Subj: Response to Memorandum: CUP-01150, VAR-01153-2015, OAK-01153-2015, SIGN-01152-2015 - Kruse Huntington Hotel Group - APN 2062-004-030

Envicom Corporation is providing this letter in response to your comments presented in the memorandum dated October 27, 2015 regarding CUP-01150, VAR-01153-2015, OAK-01153-2015, SIGN-01152-2015 - Kruse Huntington Hotel Group - APN 2062-004-030. A summary of our responses to your comments is provided below. In addition, based on the Grading and Drainage Plan prepared by Stantec provided on November 23, 2015, response #6 addresses additional updates to the impact analyses provided in the Agoura Road Oak Tree Report dated August 2015.

AGOURA ROAD HOTEL - OAK TREE REPORT

Tree Location and Project Impacts Map

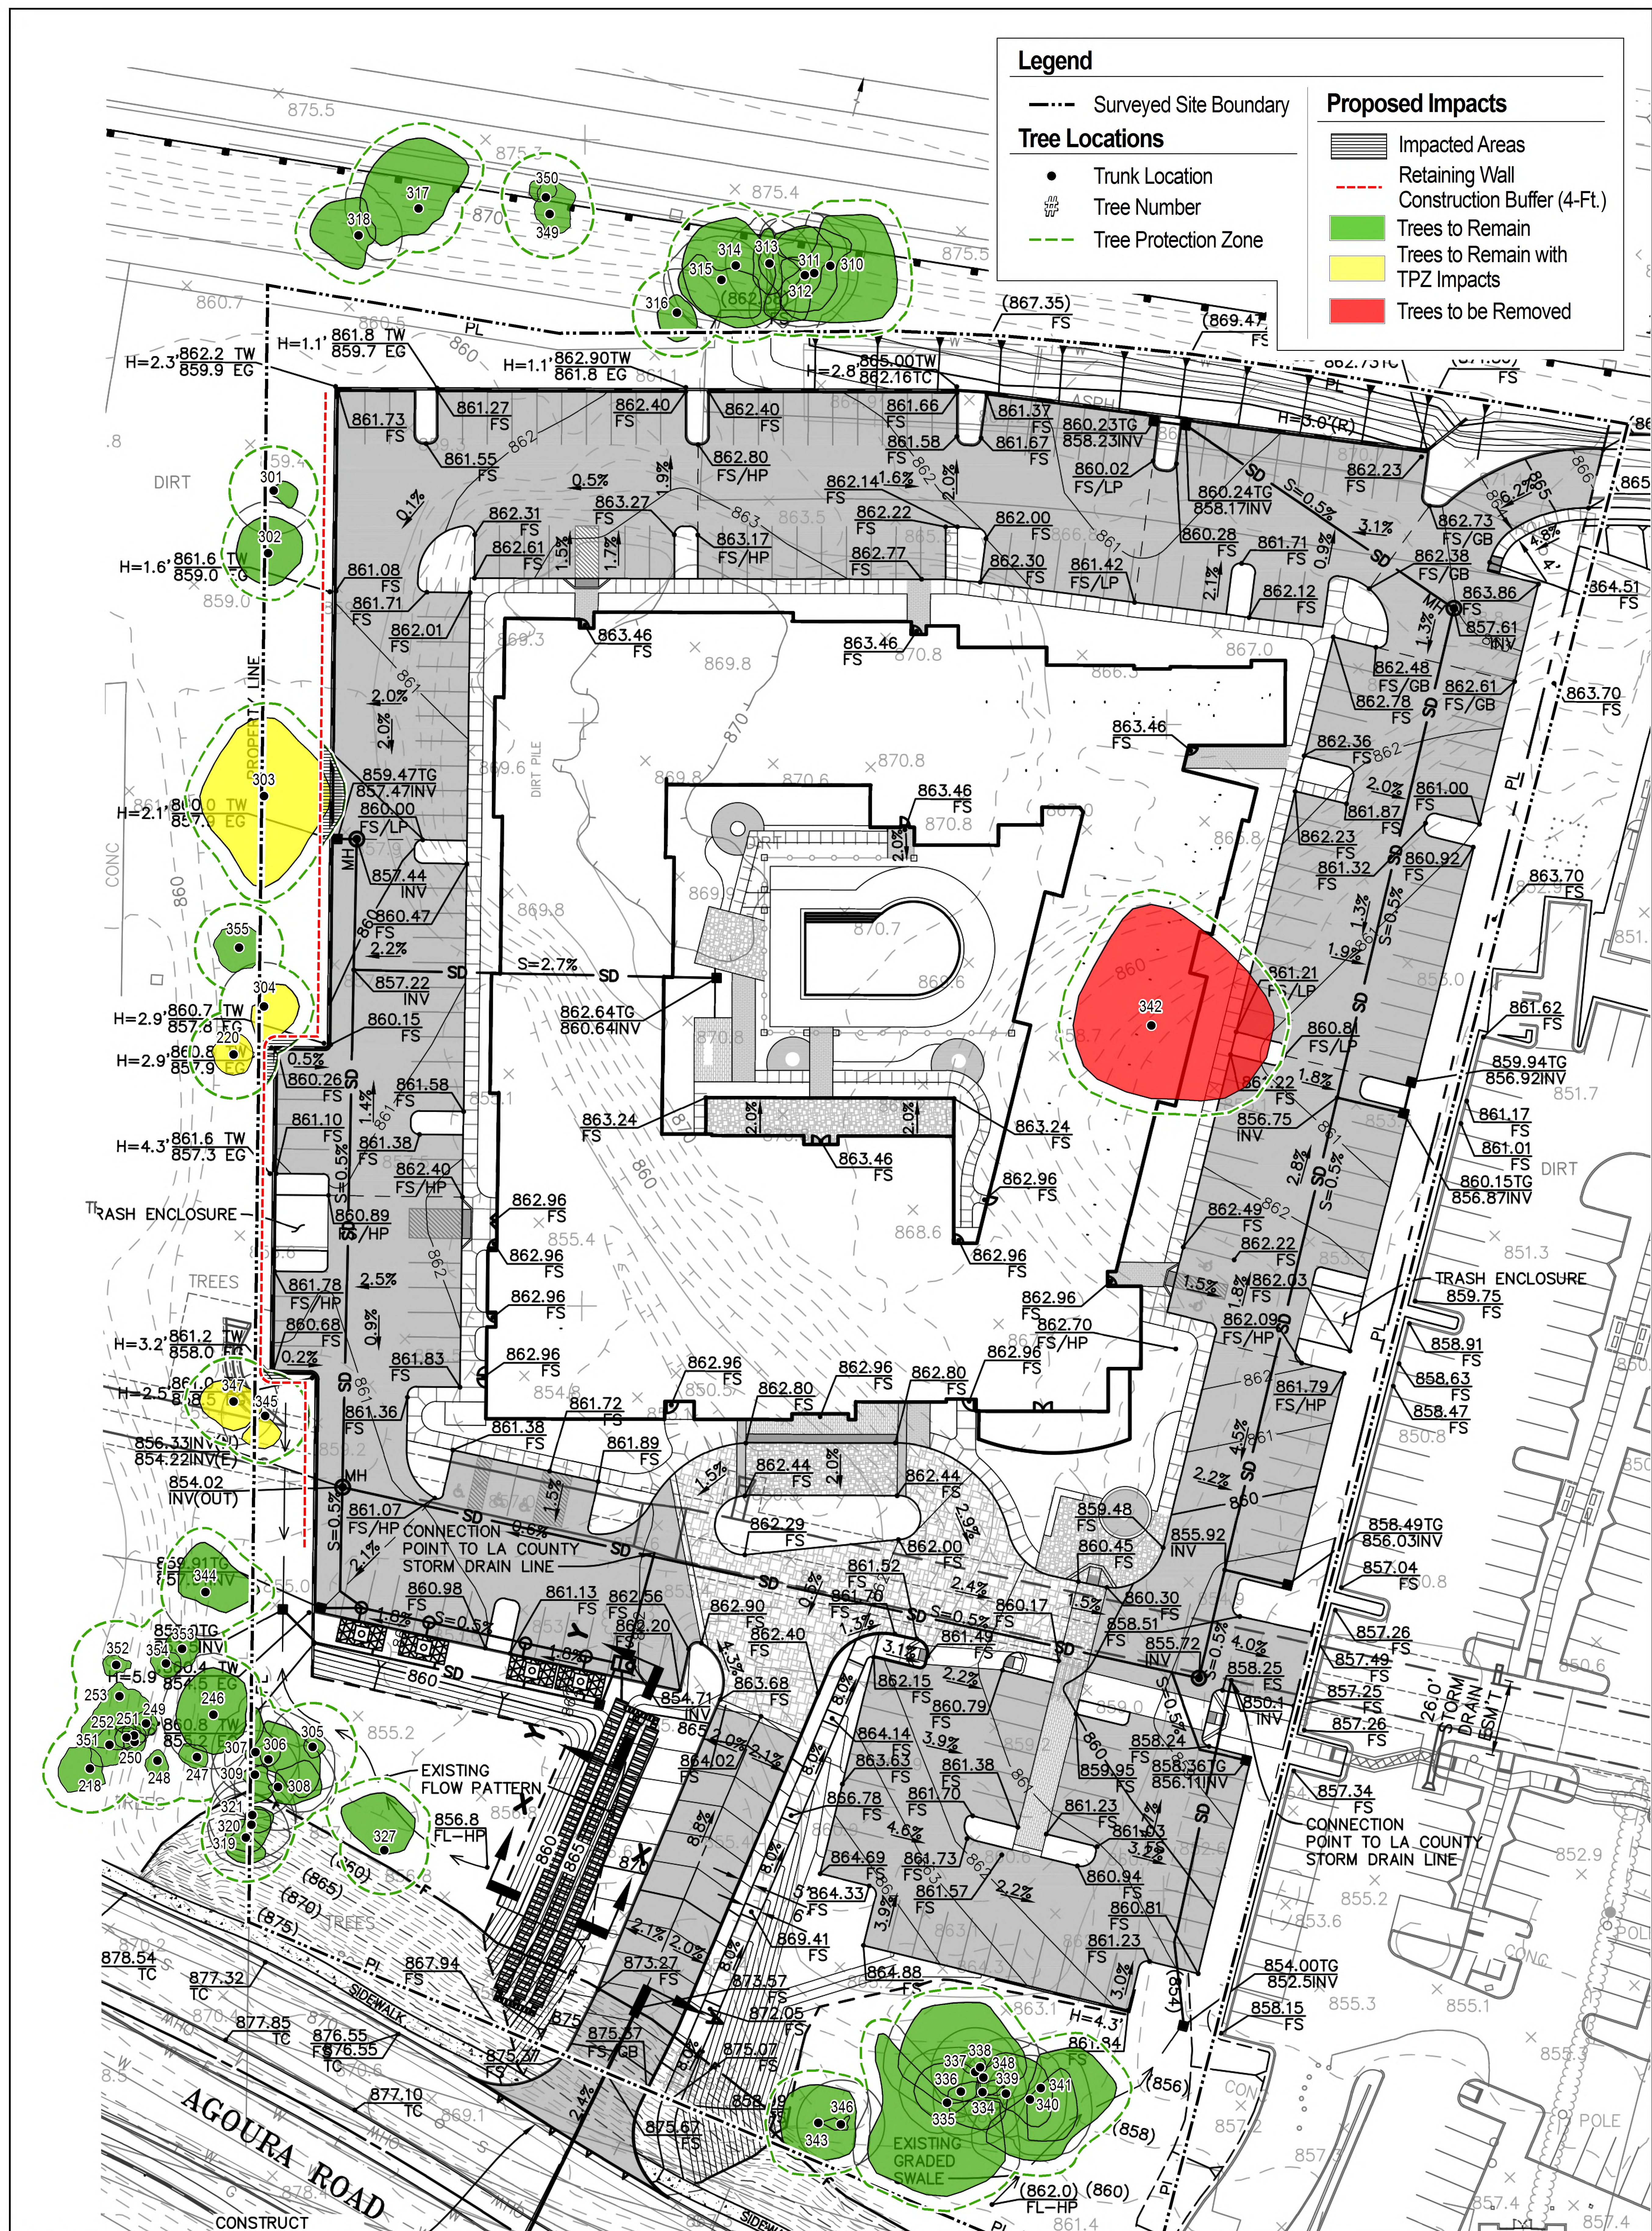
3. No encroachments will occur within the TPZ associated with Tree 335. Based on our conversation, I understand that your comment more specifically relates to whether the proposed development would provide adequate drainage for trees 334 - 341, 343, 346, and 348. As indicated on the revised Tree Location and Project Impacts Map, the existing grades and topography in the area surrounding the subject trees will be retained. The existing topography provides drainage to the northeast away from the trees to a low area outside the TPZs of the subject trees that is approximately four feet lower in elevation. Here, water will enter a storm drain located along the eastern edge of the property designed to convey flows away from the subject trees and into the existing Los Angeles County storm drain.

4. We concur and the Tree Location and Project Impacts Map has been revised to reflect this change and has been provided on Figure 1.
5. A total of 17 additional trees, one (1) onsite and 16 offsite, were included in this survey and the Tree Location and Project Impacts Map has been revised accordingly. Based on this update, the TPZ of one additional tree, Tree #220, will be encroached into during construction of the retaining wall along the western edge of the property. Specifically, the

- construction buffer of the 4' retaining wall is located approximately 4' east outside the dripline, encroaching into approximately 8% of the TPZ. This minor encroachment will not require the existing grade within the dripline nor the height of the canopy to be altered. Based on these assumptions it is not anticipated that these TPZ encroachments will significantly affect the health or vigor of the tree. The proposed Project activities will remain outside the TPZ associated with the other 16 trees. The Tree Survey Data Forms and Photos of Surveyed Trees have been provided as **Appendix 1** and **Plates 1 and 2**.
6. Based upon the updated Grading and Drainage Plan, the limits of grading in the southwest corner of the property will no longer encroach into the TPZ associated with Tree #327. The Tree Location and Project Impacts Map has been revised to reflect these changes (Figure 1).

In summary, the proposed project would result in removal of one (1) landmark tree (Tree # 342) and anticipated encroachments within the TPZ of five (5) trees, including four (4) coast live oaks (Tree #s 220, 303, 304, and 347) and one (1) scrub oak (Tree # 345). This analysis does not address potential impacts resulting from construction activities associated with the Agoura Road widening along the southern edge of the property. If you have further questions, please contact me at Envicom Corporation at (818) 879-4700.

Tree Location and Project Impacts Map

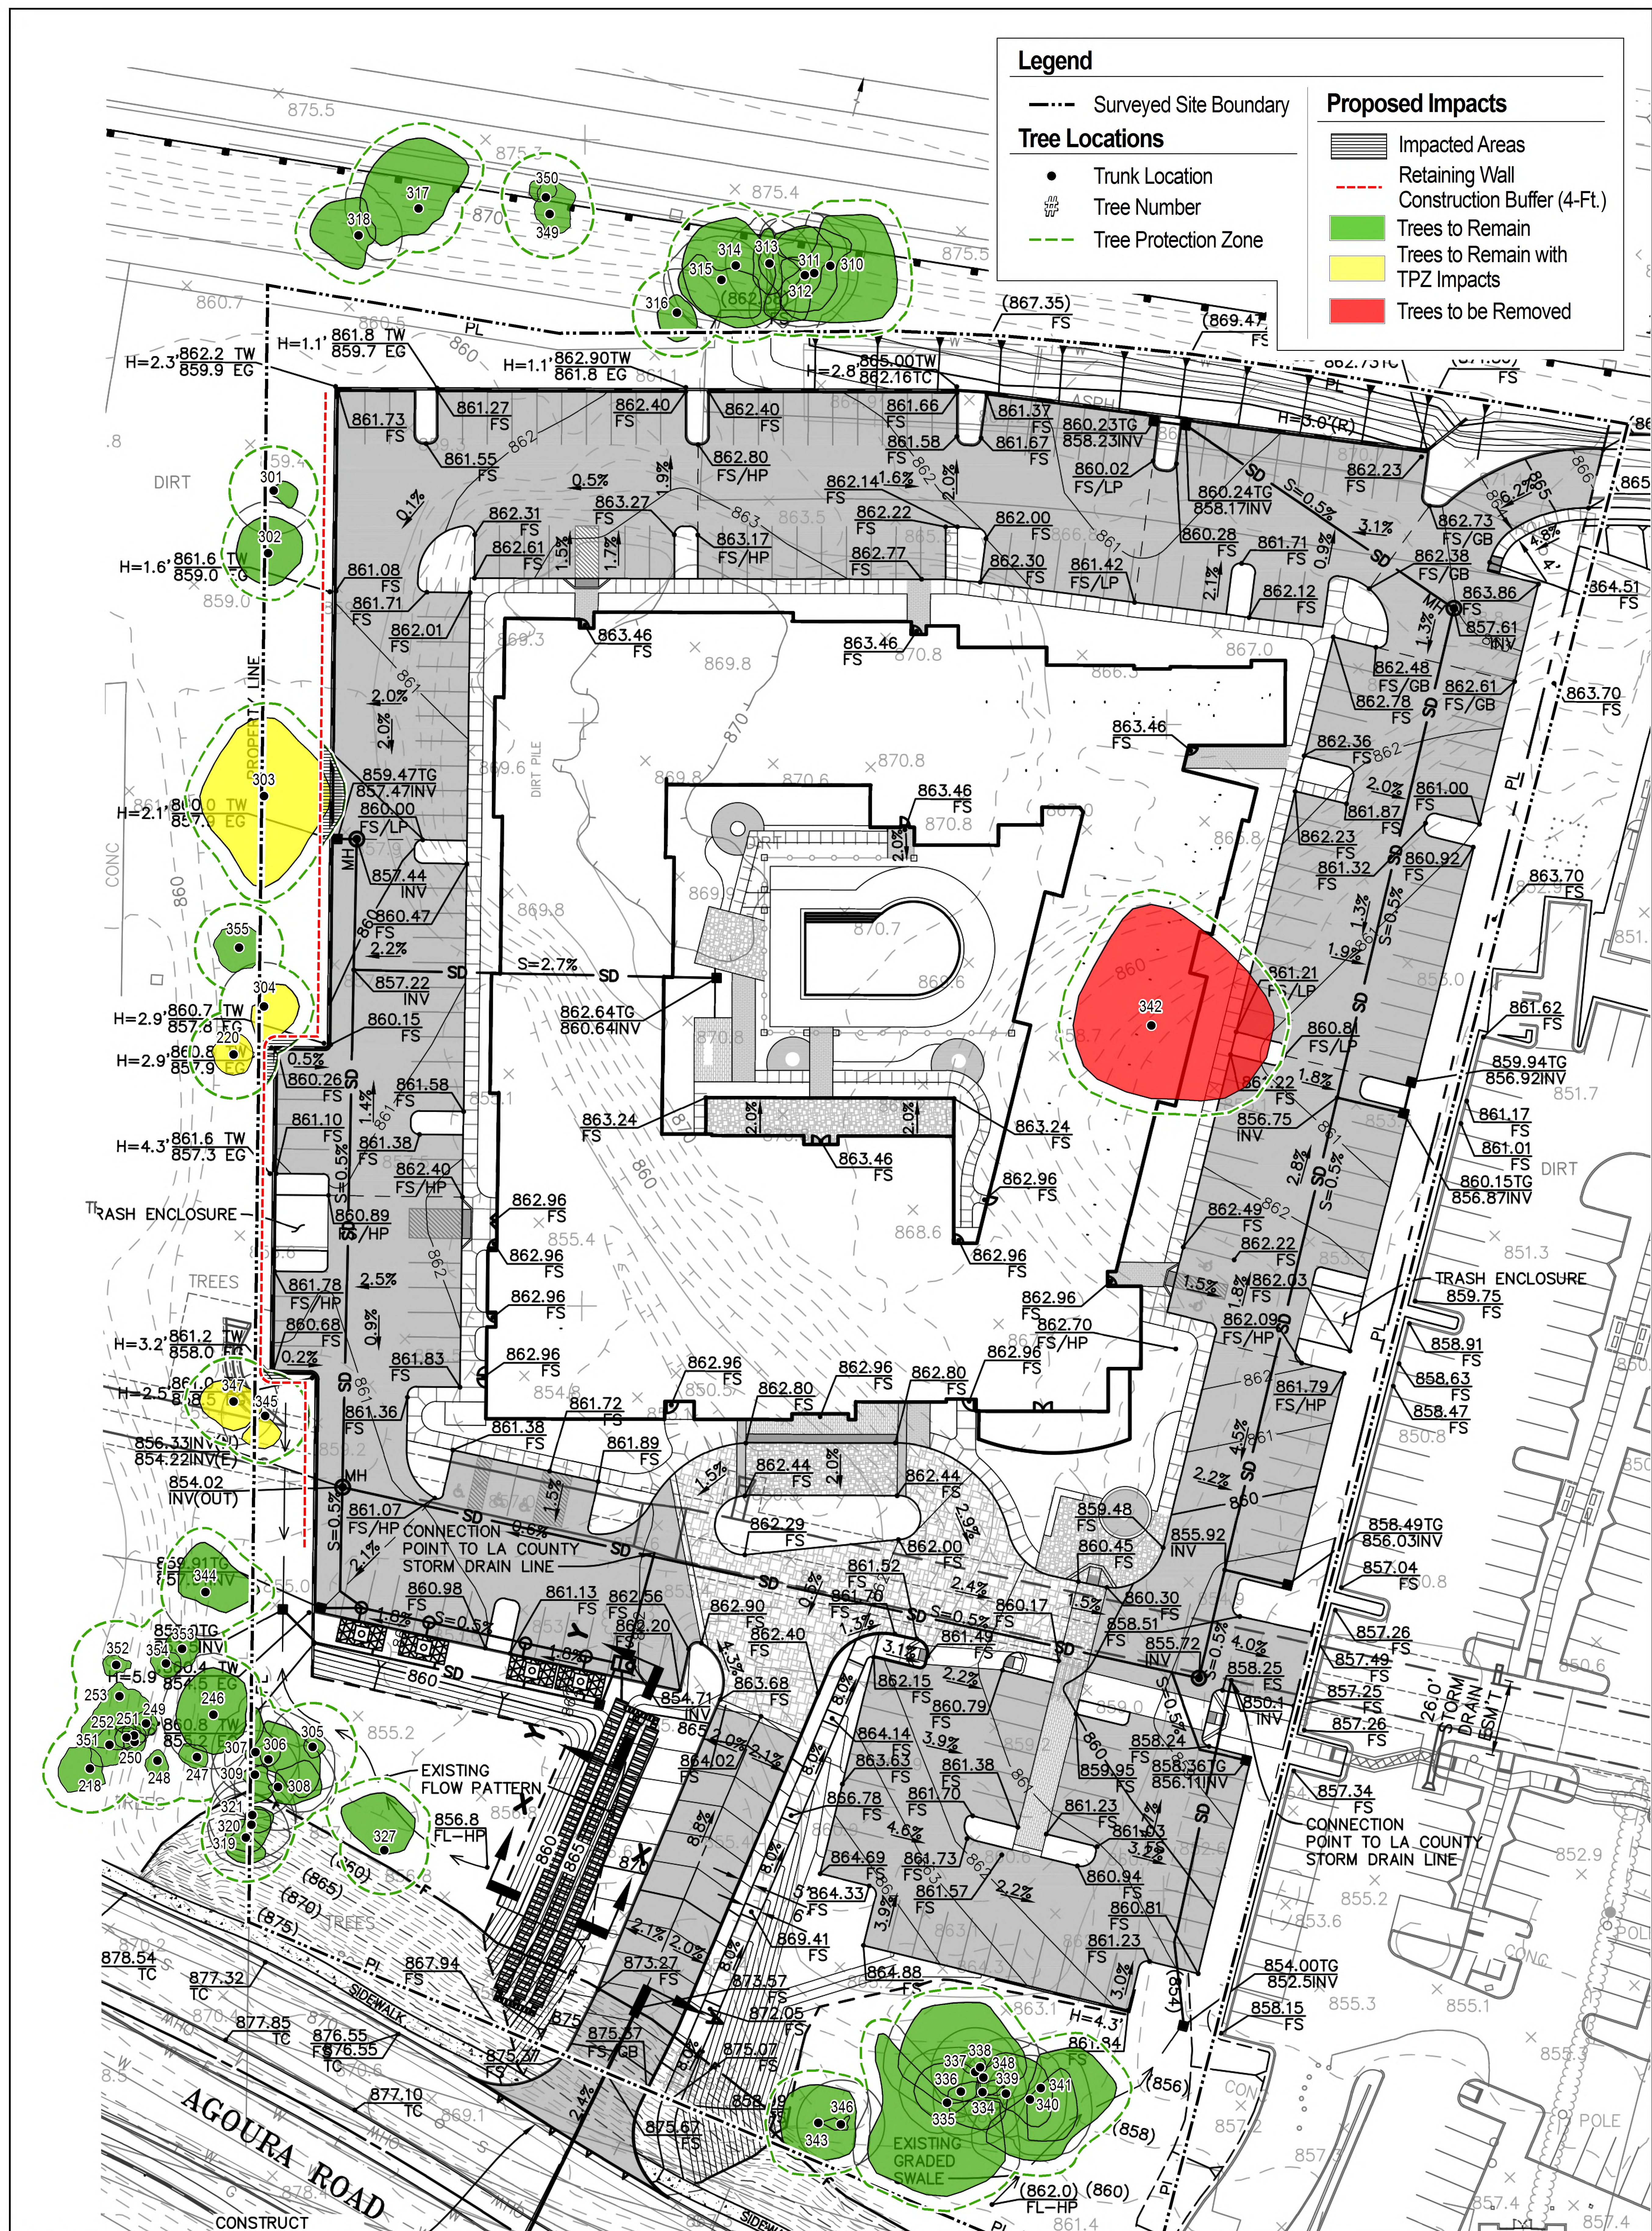
3. No encroachments will occur within the TPZ associated with Tree 335. Based on our conversation, I understand that your comment more specifically relates to whether the proposed development would provide adequate drainage for trees 334 - 341, 343, 346, and 348. As indicated on the revised Tree Location and Project Impacts Map, the existing grades and topography in the area surrounding the subject trees will be retained. The existing topography provides drainage to the northeast away from the trees to a low area outside the TPZs of the subject trees that is approximately four feet lower in elevation. Here, water will enter a storm drain located along the eastern edge of the property designed to convey flows away from the subject trees and into the existing Los Angeles County storm drain.

4. We concur and the Tree Location and Project Impacts Map has been revised to reflect this change and has been provided on Figure 1.
5. A total of 17 additional trees, one (1) onsite and 16 offsite, were included in this survey and the Tree Location and Project Impacts Map has been revised accordingly. Based on this update, the TPZ of one additional tree, Tree #220, will be encroached into during construction of the retaining wall along the western edge of the property. Specifically, the

- construction buffer of the 4' retaining wall is located approximately 4' east outside the dripline, encroaching into approximately 8% of the TPZ. This minor encroachment will not require the existing grade within the dripline nor the height of the canopy to be altered. Based on these assumptions it is not anticipated that these TPZ encroachments will significantly affect the health or vigor of the tree. The proposed Project activities will remain outside the TPZ associated with the other 16 trees. The Tree Survey Data Forms and Photos of Surveyed Trees have been provided as **Appendix 1** and **Plates 1 and 2**.
6. Based upon the updated Grading and Drainage Plan, the limits of grading in the southwest corner of the property will no longer encroach into the TPZ associated with Tree #327. The Tree Location and Project Impacts Map has been revised to reflect these changes (Figure 1).

In summary, the proposed project would result in removal of one (1) landmark tree (Tree # 342) and anticipated encroachments within the TPZ of five (5) trees, including four (4) coast live oaks (Tree #s 220, 303, 304, and 347) and one (1) scrub oak (Tree # 345). This analysis does not address potential impacts resulting from construction activities associated with the Agoura Road widening along the southern edge of the property. If you have further questions, please contact me at Envicom Corporation at (818) 879-4700.
